FORM APPROVED
OMB No. 1004-0137
Expires: July 31, 2010**SUNDRY NOTICES AND REPORTS ON WELLS**
Do not use this form for proposals to drill or to re-enter an abandoned well. Use Form 3160-3 (APD) for such proposals.

*** Marathon Oil Company request approval to add perforations, to the Indian Hills Unit #26 'Morrow' formation per attached Re-Completion procedure, which includes existing and proposed wellbores, with pipe calculations and data. The lower and middle 'Morrow' are currently being produced by means of a foamer string. Marathon plans to keep producing these zones up the tubing, and are going to produce the new 'Upper Morrow' perforations up the tubing casing annulus. Surface facilities have an additional stack pack in place to accommodate this dual-completion. Once perforated, determination will be made as to the need for frac stimulation, at that time Marathon will supply further details and submittals to all appropriate agencies as required, and schedule frac job accordingly.

Indian Hills Unit No. 26

Morrow Re-Completion Procedure

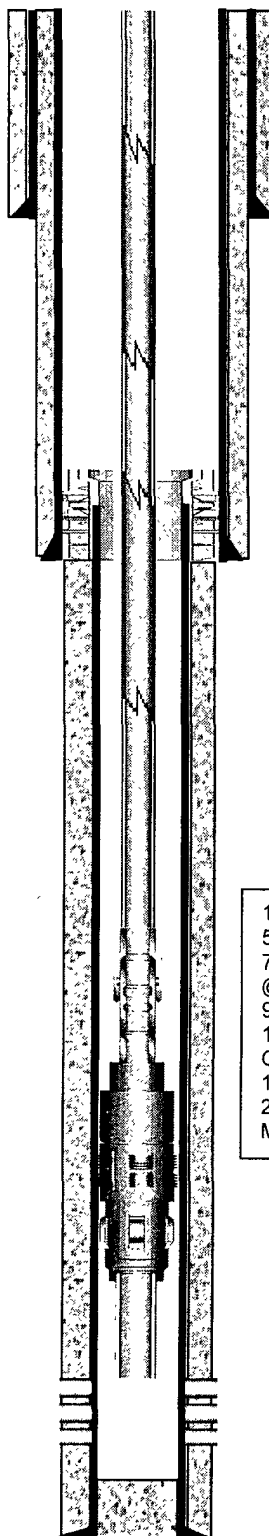
Proposed: 10,018' - 10,034' at 6-Shots Per Foot.

Proposed : Well Bore Diagram

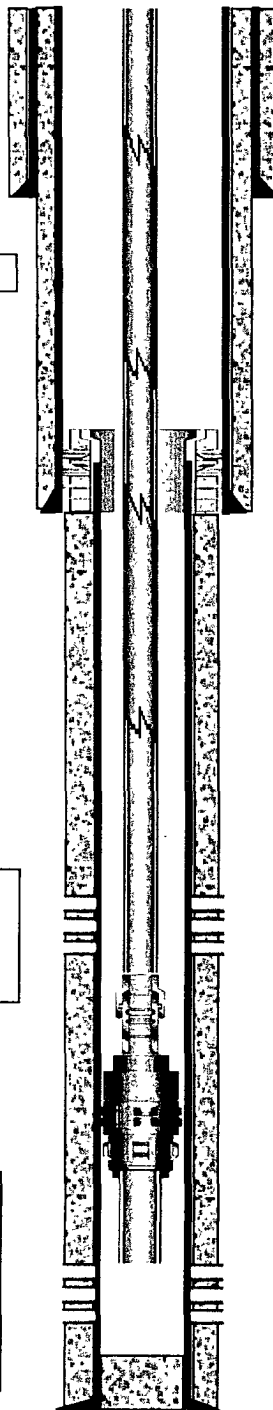
Proposed Upper
Morrow
Perfs: 10,018' -
10,034'

2 3/8" 4.7#/ft EUE 8rd L-80 8rd Tubing from surface to
9,070'
2 3/8" Blast Joints from 9,070' - 10,060'
2 3/8" Sliding Sleeve from 10,060' - 10,070'
4.5" On-off tool with 1.875" profile @ 10,070',
5" -10K PLS packer @ 10,075',
1 jt 2 3/8" L-80 8rd Tubing @ 10,106',
